City of Corpus Christi

Planning Commission

Wednesday, July 23, 2025

TECHNICAL REVIEW PLAT REQUIREMENTS
REGULAR PLANNING COMMISSION MEETING
July 23, 2025

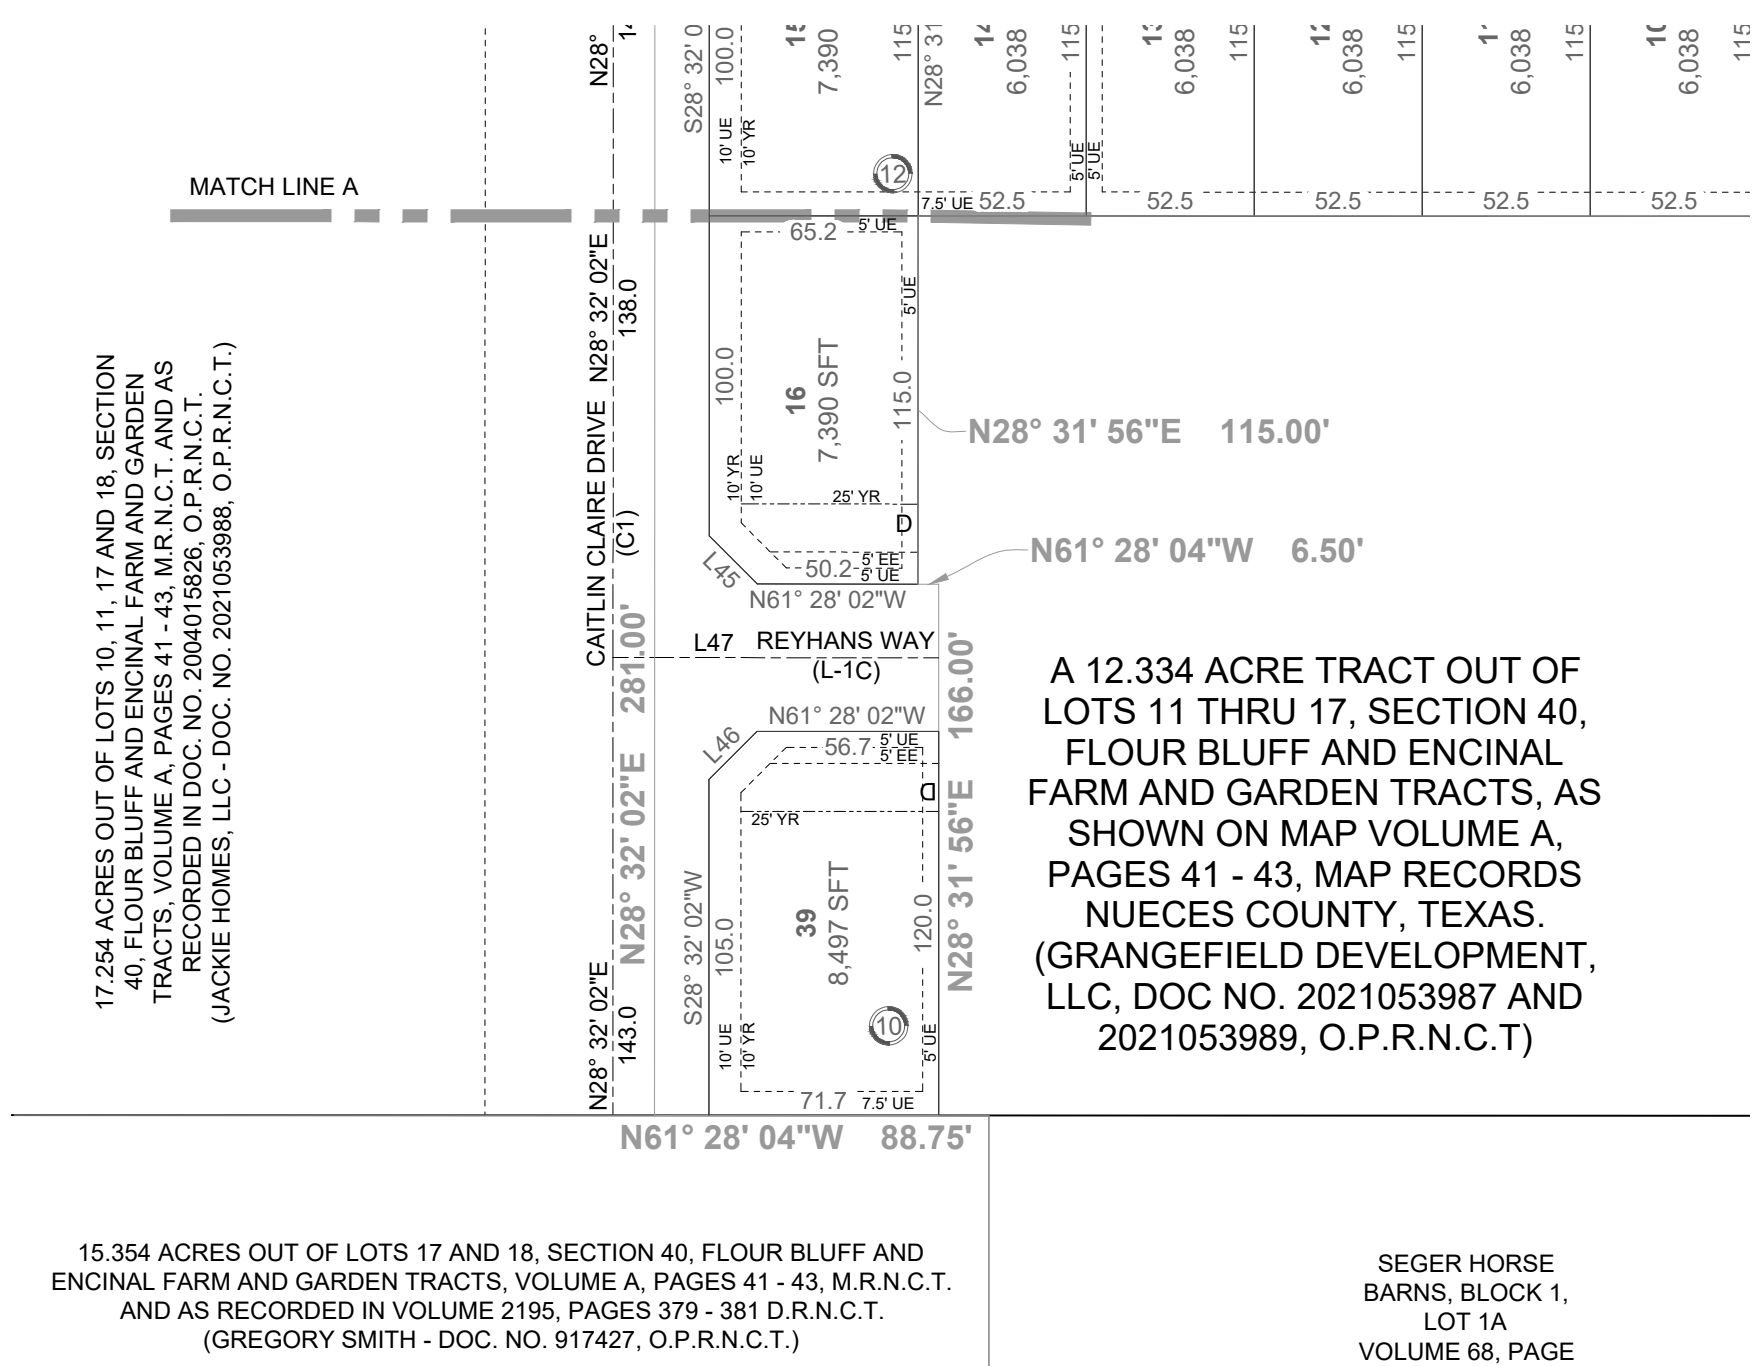
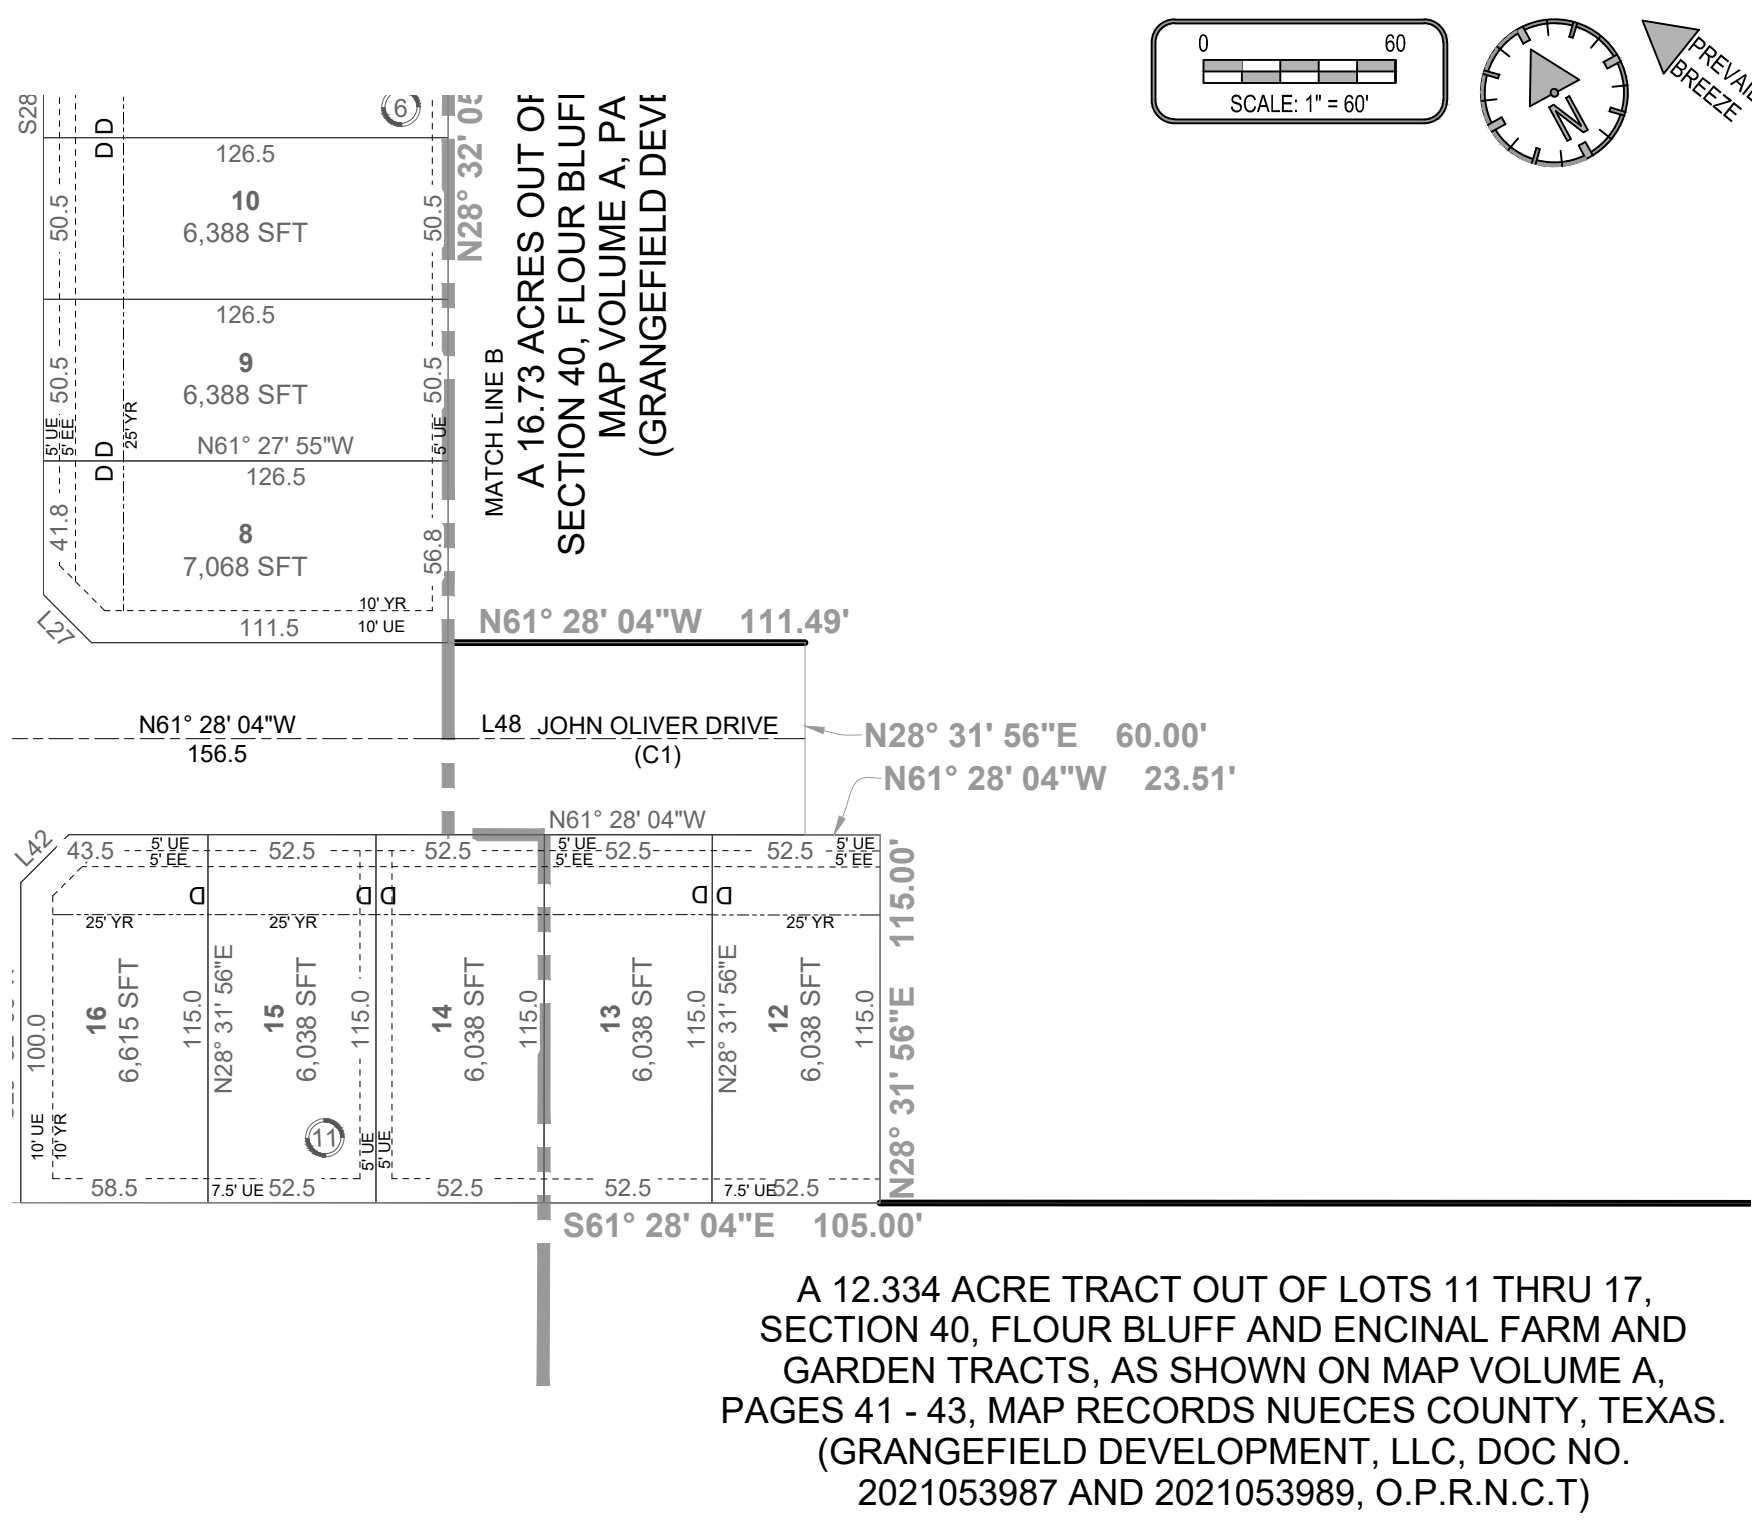
Comment ID	Page Reference	Annotation Type	Author : Department	Status	Review Comments	Applicant Response Comments
15	P001	Callout	Alex Harmon : DS	Closed	Should this be Block 6?	
15	P001	Callout	Alex Harmon : DS	Closed	Should this be Block 6?	
15	P001	Callout	Alex Harmon : DS	Closed	Should this be Block 6?	
15	P001	Callout	Alex Harmon : DS	Closed	Should this be Block 6?	
18	P001	Note	Alex Harmon : DS	Closed	Per IDM Table 6.3.5H The treated subgrade and flexible base shall extend at least 2 feet beyond the back of curb.	
18	P001	Note	Alex Harmon : DS	Closed	Per IDM Table 6.3.5H The treated subgrade and flexible base shall extend at least 2 feet beyond the back of curb.	
18	P001	Note	Alex Harmon : DS	Closed	Per IDM Table 6.3.5H The treated subgrade and flexible base shall extend at least 2 feet beyond the back of curb.	
18	P001	Note	Alex Harmon : DS	Closed	Per IDM Table 6.3.5H The treated subgrade and flexible base shall extend at least 2 feet beyond the back of curb.

19	P001	Note	Alex Harmon : DS	Closed	The City IDM Table 6.2.2.A allows for a minimum right of way of 50 ft. Adjust right of way.	
19	P001	Note	Alex Harmon : DS	Closed	The City IDM Table 6.2.2.A allows for a minimum right of way of 50 ft. Adjust right of way.	
19	P001	Note	Alex Harmon : DS	Closed	The City IDM Table 6.2.2.A allows for a minimum right of way of 50 ft. Adjust right of way.	
19	P001	Note	Alex Harmon : DS	Closed	The City IDM Table 6.2.2.A allows for a minimum right of way of 50 ft. Adjust right of way.	
14	P002	Callout	Alex Harmon : DS	Closed	For all 5' UE and EE - Change to (1) 10' U.E, unless requested otherwise.. AEP Texas and the City of Corpus Christi have a franchise agreement to work together in the same easement.	
14	P002	Callout	Alex Harmon : DS	Closed	For all 5' UE and EE - Change to (1) 10' U.E, unless requested otherwise.. AEP Texas and the City of Corpus Christi have a franchise agreement to work together in the same easement.

14	P002	Callout	Alex Harmon : DS	Closed	For all 5' UE and EE - Change to (1) 10' U.E, unless requested otherwise.. AEP Texas and the City of Corpus Christi have a franchise agreement to work together in the same easement.

Comment ID	Page Reference	Annotation Type	Author : Department	Status	Review Comments	Applicant Response Comments
17	P002	Note	Alex Harmon : DS	Closed	06/16/25 UPDATE: Only the USACE can determine whether this wetland is actually jurisdictional. Reach out to USACE for LJD The US Fish and Wildlife Service (FWS) identifies one wetland area within this proposed platted area. Identify area on this plat. Approval from the USACE is needed prior to recordation/construction in these areas.	
17	P002	Note	Alex Harmon : DS	Closed	6/16/25 UPDATE: Only the USACE can determine if wetlands are actually jurisdictional. Reach out to USACE. The US Fish and Wildlife Service (FWS) identifies one wetland area within this proposed platted area. Identify area on this plat. Approval from the USACE is needed prior to recordation/construction in these areas.	
17	P002	Note	Alex Harmon : DS	Closed	The US Fish and Wildlife Service (FWS) identifies one wetland area within this proposed platted area. Identify area on this plat. Approval from the USACE is needed prior to recordation/construction in these areas.

30	P001	Note	Caleb Wong : STREET	Closed	PW STR: Please provide typical street section specifications on pavement section materials and thicknesses.	
30	P001	Note	Caleb Wong : STREET	Closed	PW STR: Please provide typical street section specifications on pavement section materials and thicknesses.	
30	P001	Note	Caleb Wong : STREET	Closed	PW STR: Please provide typical street section specifications on pavement section materials and thicknesses.	
30	P001	Note	Caleb Wong : STREET	Closed	PW STR: Please provide typical street section specifications on pavement section materials and thicknesses.	
31	P001	Note	Caleb Wong : STREET	Closed	PW STR: Google Earth shows a property with singular access to Flour Bluff Dr. The proposed plans show that the singular access is to be demolished. How will access for property owner be provided? Or is the unit abandoned?	
31	P001	Note	Caleb Wong : STREET	Closed	PW STR: Google Earth shows a property with singular access to Flour Bluff Dr. The proposed plans show that the singular access is to be demolished. How will access for property owner be provided? Or is the unit abandoned?

31	P001	Note	Caleb Wong : STREET	Closed	PW STR: Google Earth shows a property with singular access to Flour Bluff Dr. The proposed plans show that the singular access is to be demolished. How will access for property owner be provided? Or is the unit abandoned?

Comment ID	Page Reference	Annotation Type	Author : Department	Status	Review Comments	Applicant Response Comments
28	P002	Note	Caleb Wong : STREET	Closed	PW STR: Project should address the vertical alignment of the proposed tie-ins to existing infrastructure inside and outside project limits. Vertical alignment should not restrict flow to inlets and should allow smooth riding surface. If current project limits don't allow this, the project limits should be altered to address.	
28	P002	Note	Caleb Wong : STREET	Closed	PW STR: Project should address the vertical alignment of the proposed tie-ins to existing infrastructure inside and outside project limits. Vertical alignment should not restrict flow to inlets and should allow smooth riding surface. If current project limits don't allow this, the project limits should be altered to address.	
29	P002	Note	Caleb Wong : STREET	Closed	PW STR: Vertical alignment of side streets should not protrude into higher classification roadways.

PLAT OF
LYNNWOOD PLACE UNIT 1
BLOCK "D", LOTS 1 - 7

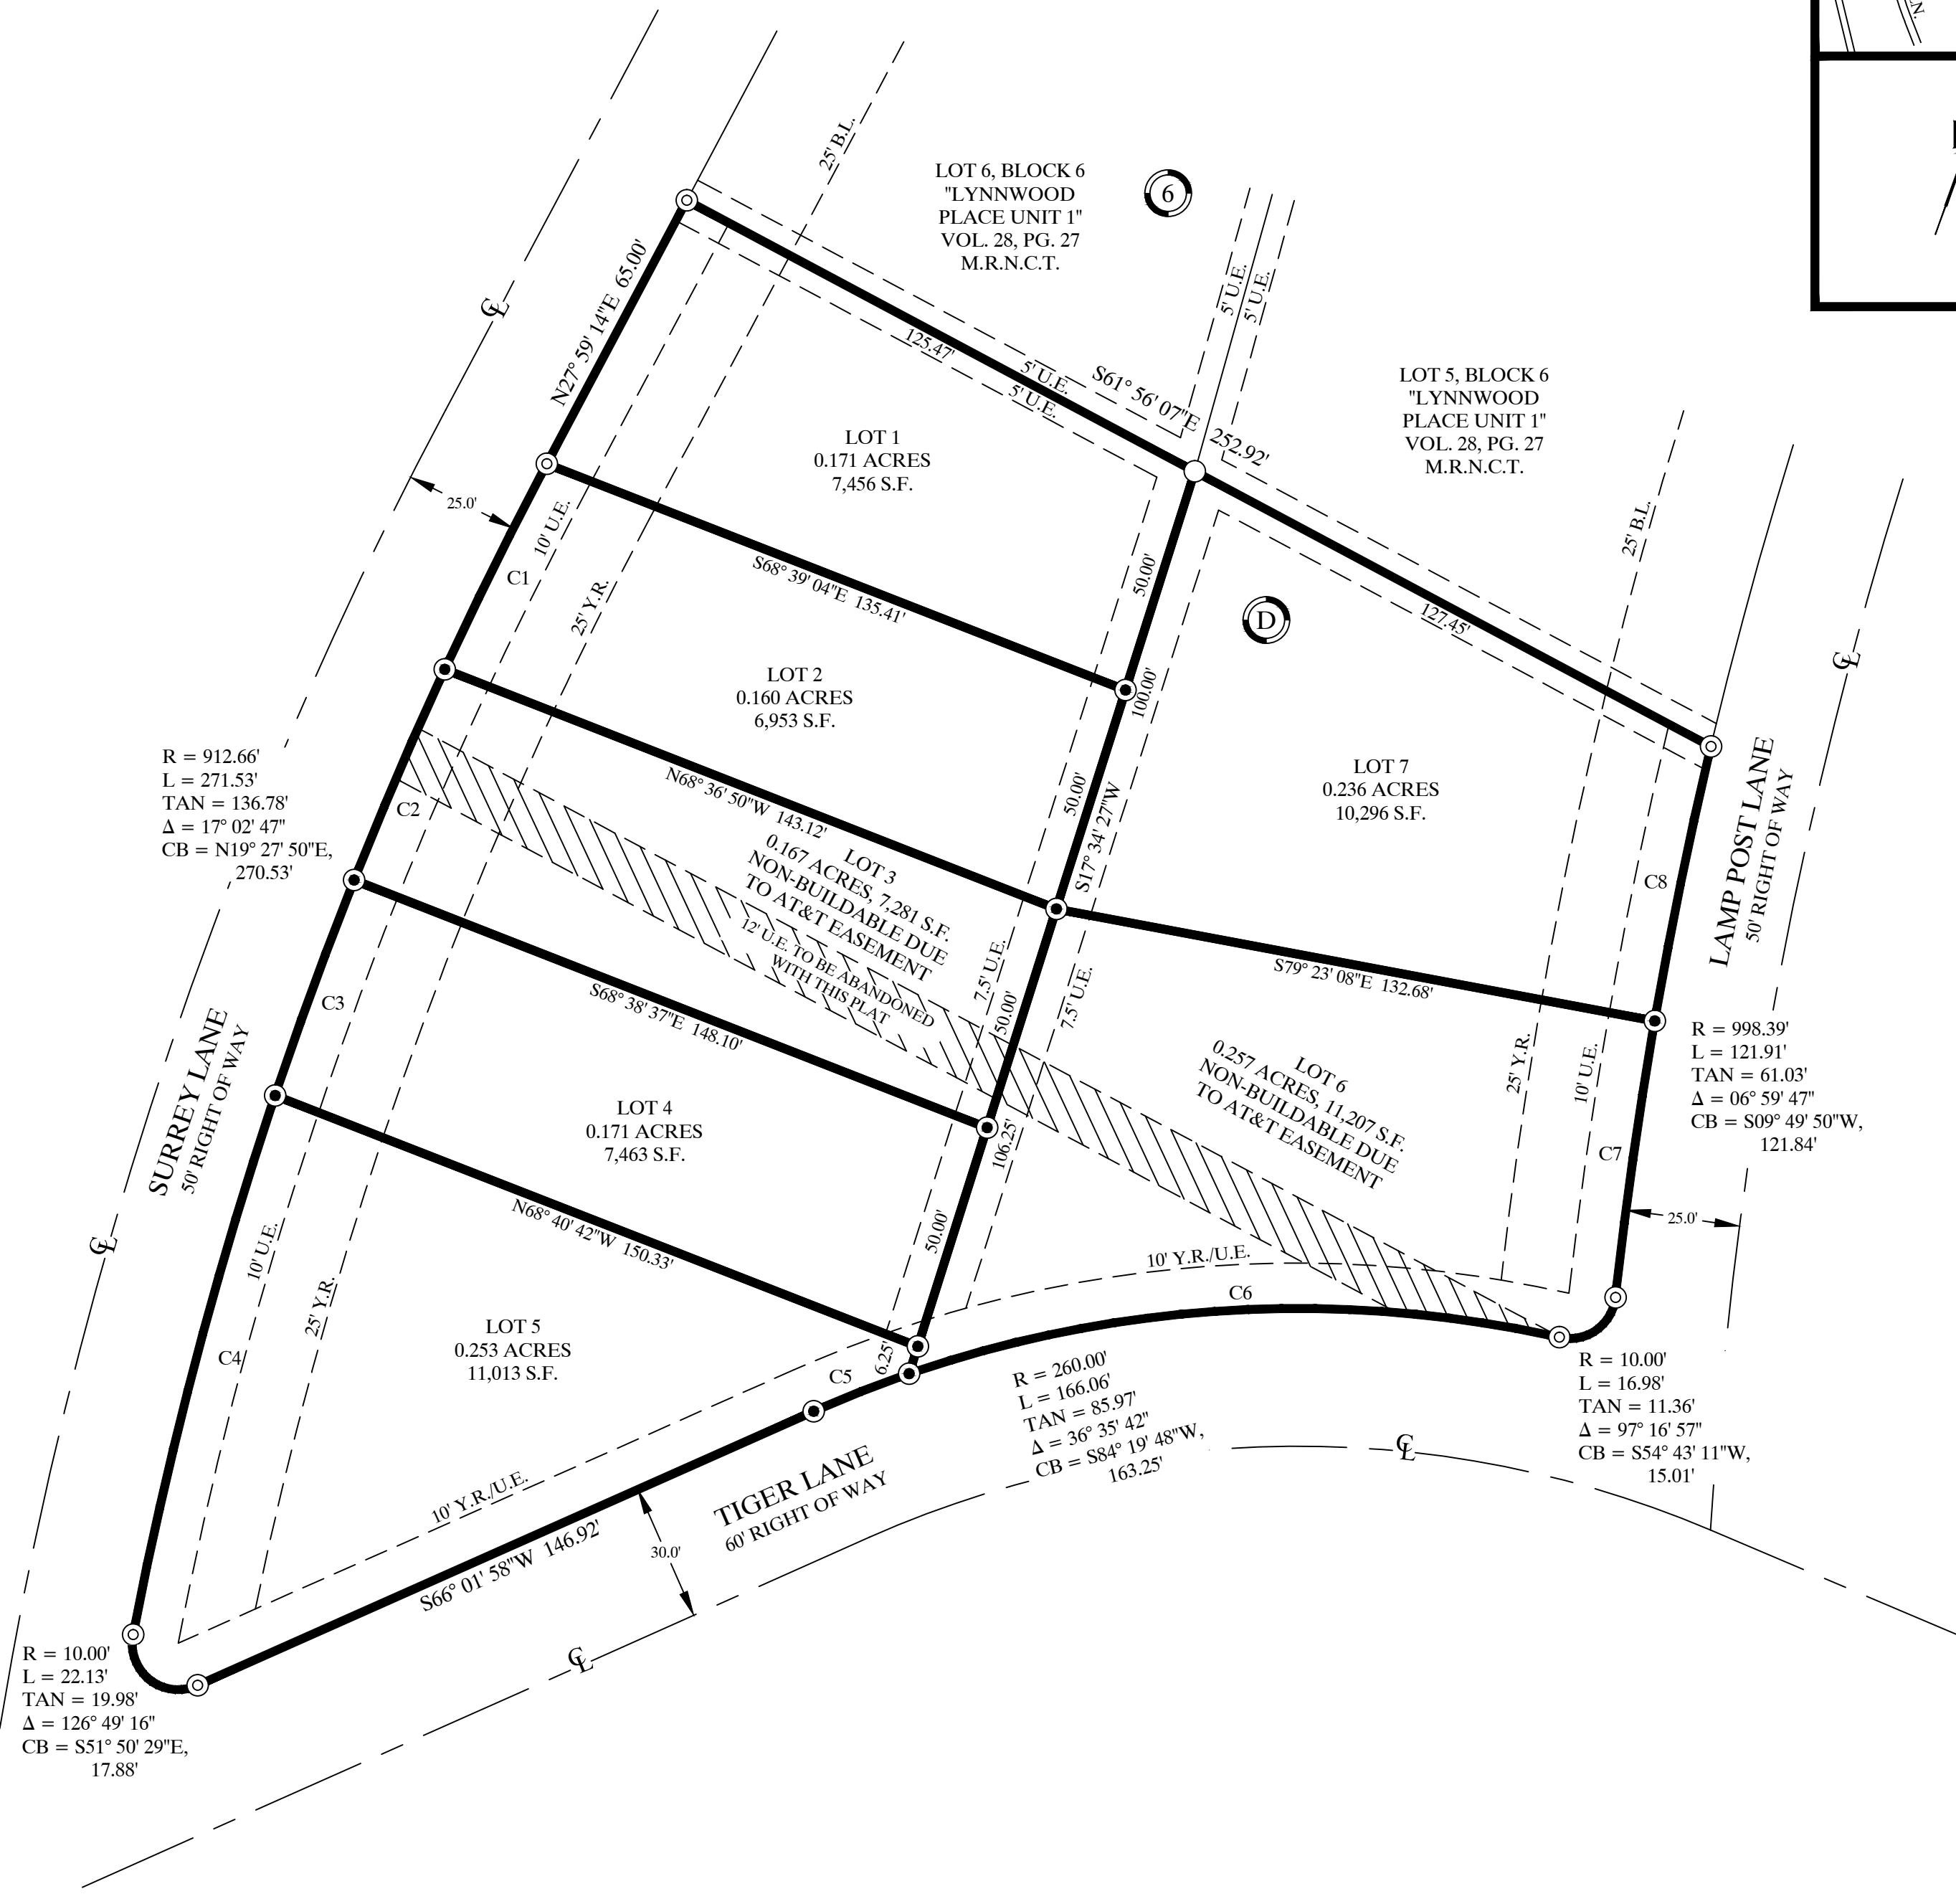
Comment ID	Page Reference	Annotation Type	Author : Department	Status	Review Comments	Applicant Response Comments
2	P001	Note	Mark Zans : LD	Closed	Change Al Raymond name to Michael Dice	
3	P001	Note	Mark Zans : LD	Closed	Change all year references to 2025.	
4	P001	Note	Mark Zans : LD	Closed	Plat is a replat.	
5	P001	Note	Mark Zans : LD	Closed	This plat is on the 30-day tract for approval, approval with Conditions, or disapproval by ##/## (date). The deadline for revisions to be submitted is ##/## (date).	
6	P001	Note	Mark Zans : LD	Closed	The plat will be recommended as Conditional Approval for Resolution comments received and that have remained Open and unmet.	
7	P001	Note	Mark Zans : LD	Closed	A request or response may be made for an additional 30 days for Public Notice plat with a Waiver or to resolve Open comments. This request must be made directly to Development Services within the 30-day initial period.

10	P001	Note	Mark Zans : LD	Closed	Public Improvement Plans must be submitted prior to plat approval.	
14	P001	Note	Mark Zans : LD	Closed	Park fee: 7 new lots x 462.50 = \$3,237.50	
18	P001	Note	Mark Zans : LD	Closed	<p>Fire comments:</p> <p>Purpose of Plat is to create lots to sell. If construction of single family homes takes place, the fire hydrants are within acceptable distance and the roads are existing. If multiunit construction is proposed, further review will be required. Fire has no further comments at this time.</p>

Comment ID	Page Reference	Annotation Type	Author : Department	Status	Review Comments	Applicant Response Comments
17	P001	Note	Marcos Castaneda : STREET	Closed	Residential: Please review IDM Ch. 3.05: No Adverse Impacts. For new developments and other improvements that will increase the impervious cover, decrease the time of concentration (Tc), or increase peak flows from drainage areas, mitigation of adverse storm water impacts shall be required. Mitigation methods shall be designed to release the post-development storm water runoff from a site at a controlled rate, which does not exceed the predeveloped peak runoff rate. Habitable structures must be mitigated to the 100 yr-storm event, per UDC 8.2.8.	
15	P001	Note	John Gonzales : WW	Closed	Wastewater construction is required for platting (UDC 1.2.1.D & 8.2.7; Wastewater Collection System Standards). All wastewater improvements to be address during Public Improvements Phase.

16	P001	Note	John Gonzales : WW	Closed	Water construction is not required for platting (UDC 1.2.1.D & 8.2.6; Water Distribution Standards).
